**SOUTH HOLLAND CO
HOUSING & PLANNING**

REVISIONS 1 12/1/79. fascia changed for halo illuminated letters, blue 30mm. New externally illuminated hanging sign.	PRELIM NAME LLOYDS TSB 6 WEST STREET LONG SUTTON PREVIOUS CODE 5045057777-214	DESCRIPTION PROCESSED SIGNAGE
PROJECT NO. DRAWING NO. 101	DATE 19-6-98	SCALE 1:50
PROJECT NO. DRAWING NO. 101	DATE 19-6-98	SCALE 1:50
PROJECT NO. DRAWING NO. 101	DATE 19-6-98	SCALE 1:50

FRONT ELEVATION

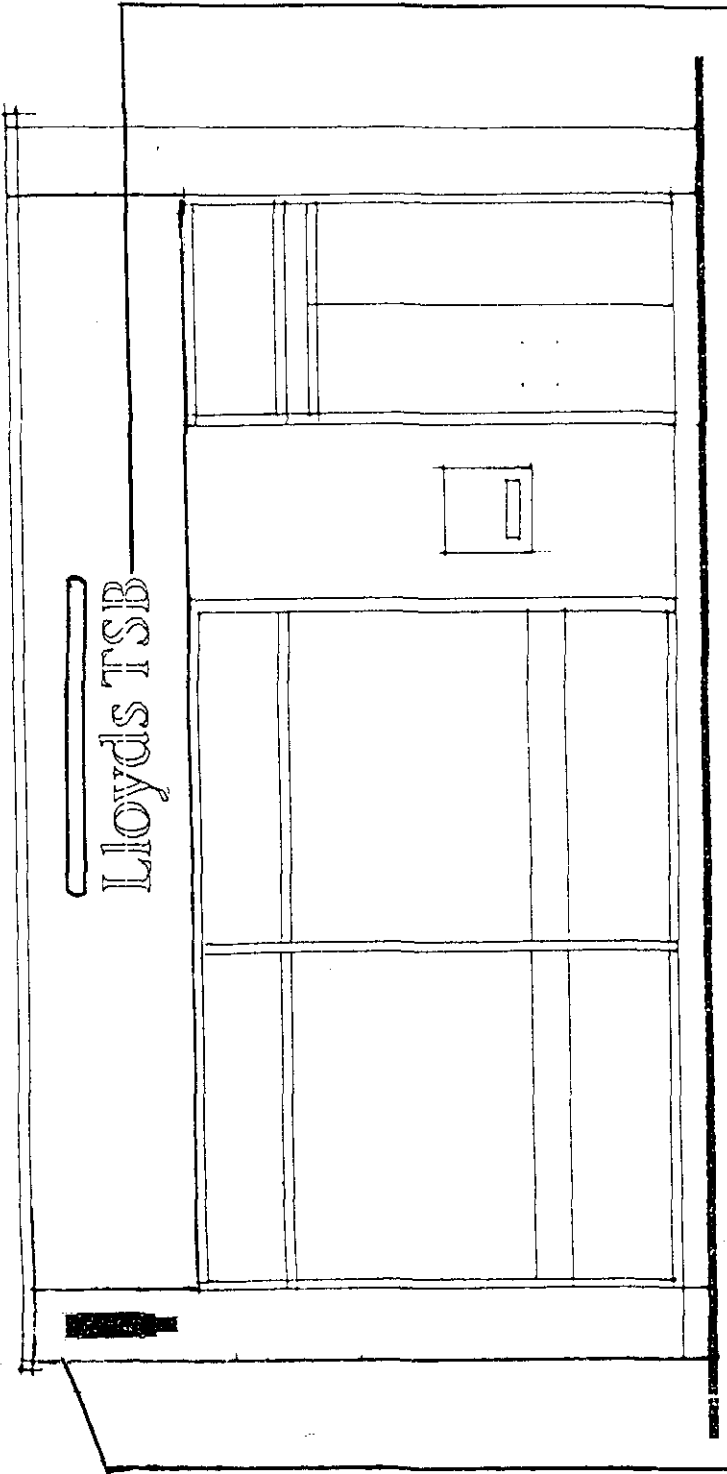
② EXTERNALLY - ILLUMINATED FLAT LETTERS ON BLUE TRAY. 22/4/99
PROTECTIVE SIGN - BUT NON - ILLUMINATED - *AB*
